SUBJECT: RIVER BEND STATION, UNIT 1 - AMENDMENT NO. 33 TO FACILITY  
OPERATING LICENSE NO. NPF-47 (TAC NO. 71204)

AMENDMENT TO FACILITY OPERATING LICENSE

Amendment No.33  
License No. NPF-47

SAFETY EVALUATION BY THE OFFICE OF NUCLEAR REACTOR REGULATION  
RELATED TO AMENDMENT NO. 33 TO FACILITY OPERATING LICENSE NO. NPF-47  
GULF STATES UTILITIES COMPANY  
RIVER BEND STATION, UNIT 1  
DOCKET NO. 50-458

**FIGURE 3.2.1-7**

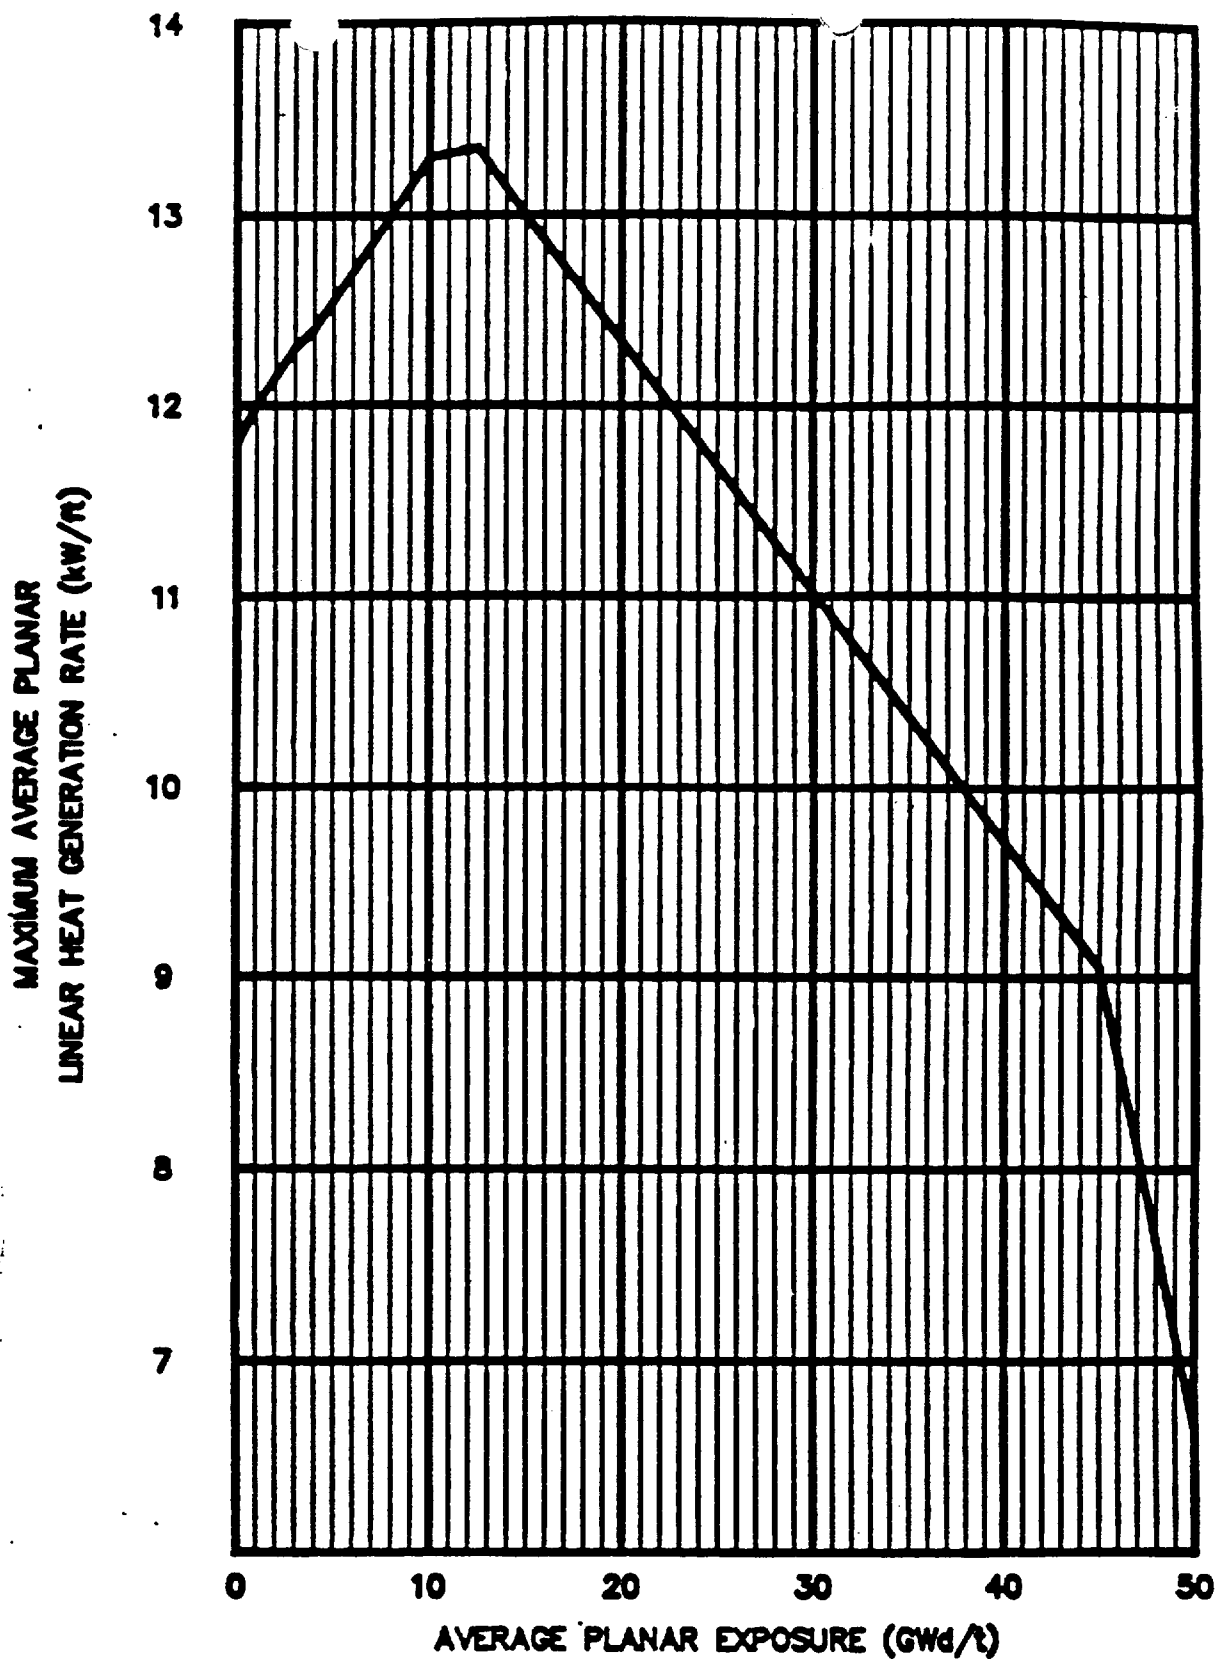
### 2. Figures 3.2.1-7 and 3.2.1-8

These figures have been added and address the MAPLHGR versus Average Planar Exposure for the new fuel types. These additions are acceptable.

FIGURE 3.2.3-1  
 $MCPR_f$

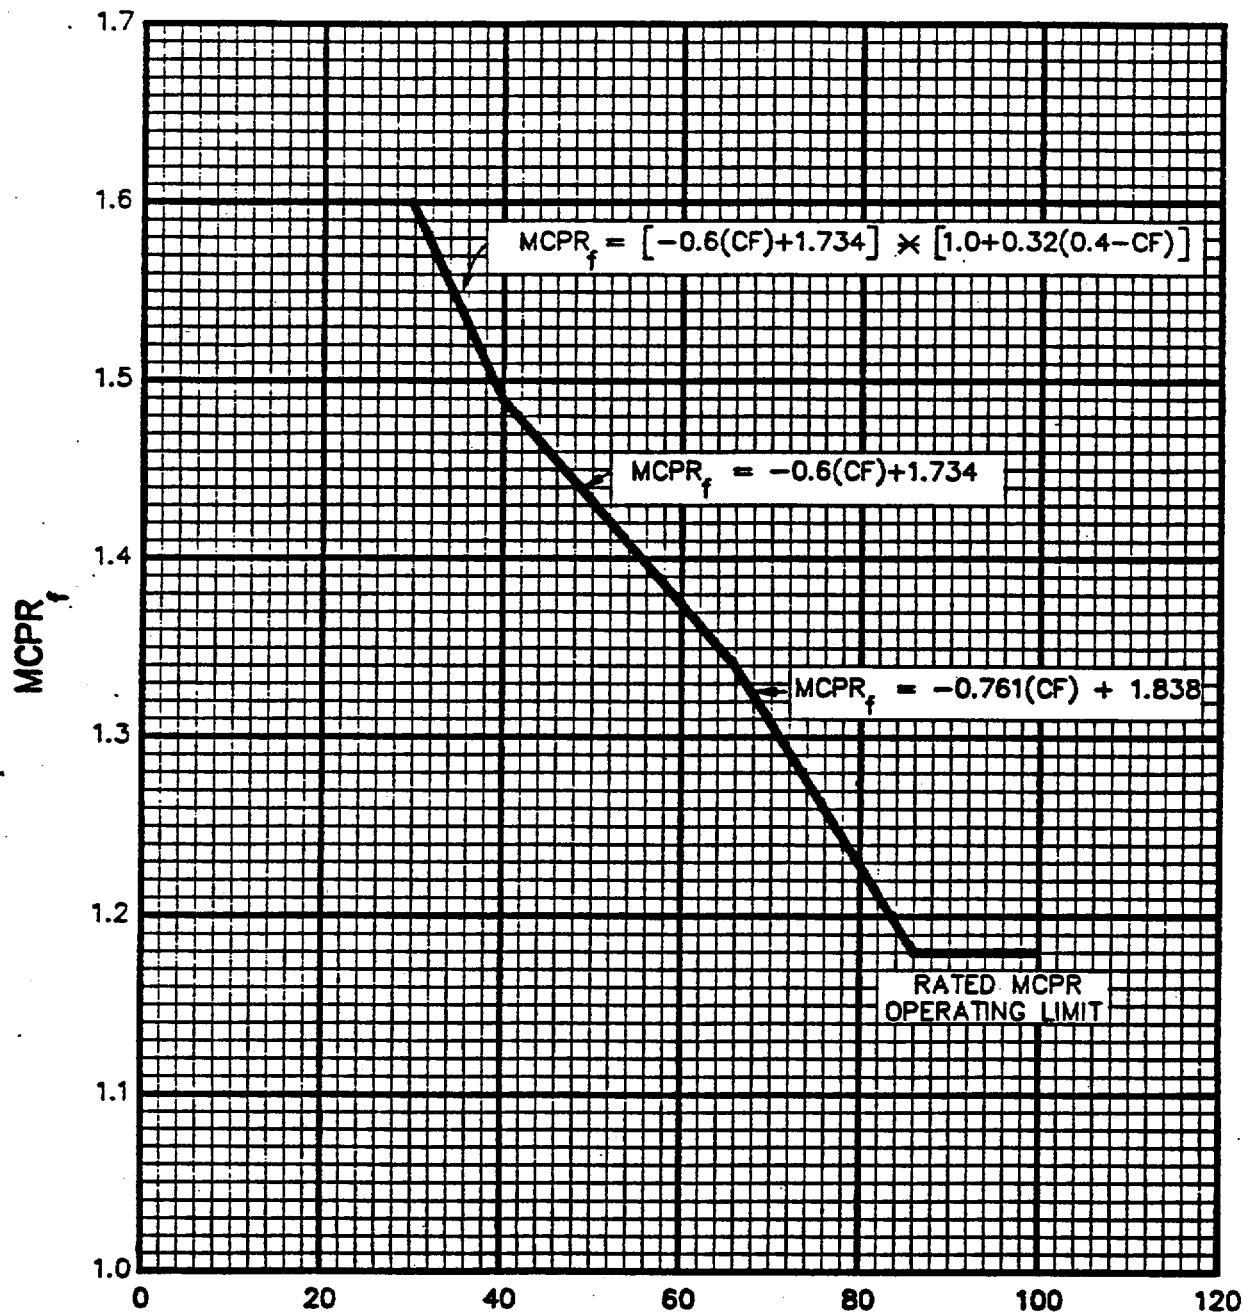
The amendment provides the bundle Maximum Average Planar Linear Heat Generation Rate (MAPLHGR) and the higher Linear Heat Generation Rate (LHGR) limits for the new fuel being added for the second reload. The amendment also revises Technical Specification Section 5, Design Features, Item 5.3.1 to generalize the fuel details to allow referencing future fuel designs included in the "General Electric Standard Application for Reactor Fuels" (GESTAR), Technical Specification Bases 3/4.2.1 to reference Technical Specification 3.2.1 instead of referencing individual MAPLHGR curves, and Figure 3.2.3-1 to show the revised flow dependent Minimum Critical Power Ratio (MCPR) operating limit curve.
